Official Transcript of Proceedings
NUCLEAR REGULATORY COMMISSION

Title: ACRS Plant Operations and Fire
Protection Subcommittee

Date: July 12, 2011

12 Mr. Girija Shukla of the ACRS Staff is the
13 Designated Federal Official for this meeting. The
14 Subcommittee will hear presentations from NRC Staff
15 and the Applicant, Tennessee Valley Authority,
16 regarding the status of construction, inspection, and
17 licensing activities related to Watts Bar Nuclear
18 Plant Unit 2.

ICS Change Review

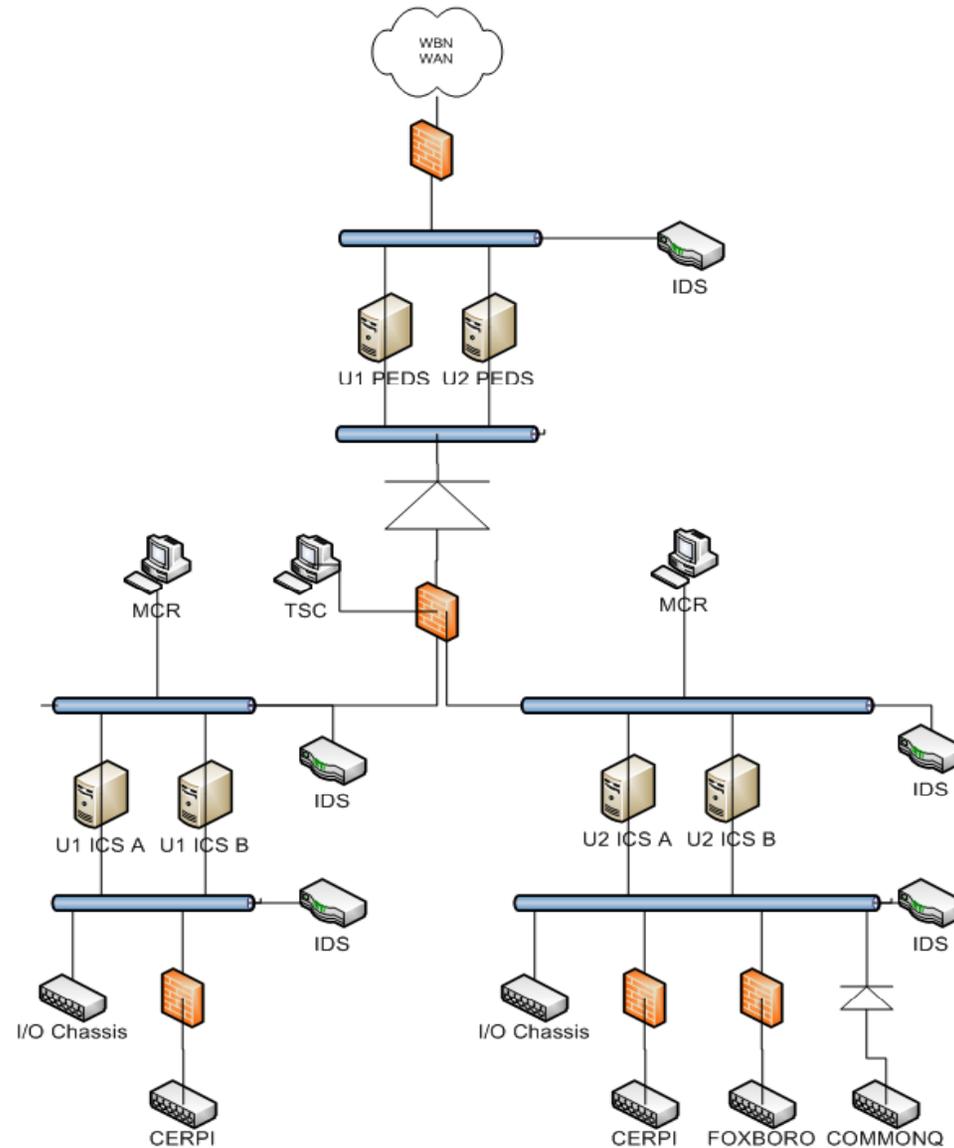
21 MEMBER BROWN: This big, big, big data
22 diode that you show up there, a very impressive data
23 diode.

1 What is the nature -- I didn't -- there was -- I could
2 not find any description of the nature of this data
3 diode. Is it a -- and my question goes into the form
4 of, that there's two questions.

10 MEMBER BROWN: One other question, just to
11 be -- back on slide 32, the TSC is shown as coming
12 through a firewall from the two networks, two process
13 computer networks.

15 MEMBER BROWN: Single firewall, that's
16 what it looks like, on the box. And I guess -- and
17 this is based on just experience, no other basis for
18 this question, in that firewalls I have found in many
19 circuits start blocking information, because they get
20 confused.

8 MR. HILMES: Generally, that is correct.
9 This is Unit 2, this is Unit 1. We have a common TSC,
10 okay, for both units. And these TSC computers do go
11 to two separate firewalls here, for Unit 1 and Unit 2.

9 MR. HILMES: I have a very detailed
10 drawing I can provide you with.
